## PERMISSION APPLICATION Comité de déroppiments TO THE COMMITTEE OF ADJUSTMENT PANEL 3

Site Address: 6 White Cedar

File No.: D08-02-23/A-00207 Report Date: November 09, 2023 Hearing Date: November 14, 2023

Figure 2. Applicant's proposal. Upper wall extends the full width of the lower wall, and is the main roof line.

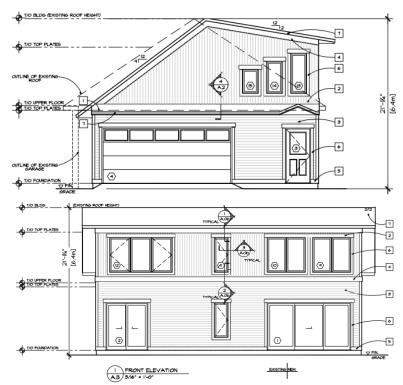
The proposed expansion would also increase the height of the northern exterior wall. Zoning By-law Table 55 (5) states that the maximum height of the exterior walls is not to exceed 3.2 metres. The applicant requires a secondary Minor Variance to permit the increased height. The proposed addition raises the height of the walls of one side of the garage. As the proposed addition extends to the full width of the lower wall, it is not a dormer (see Figures 1 and 2, below). Therefore, the application must address the wall height provision in the above-noted Table.
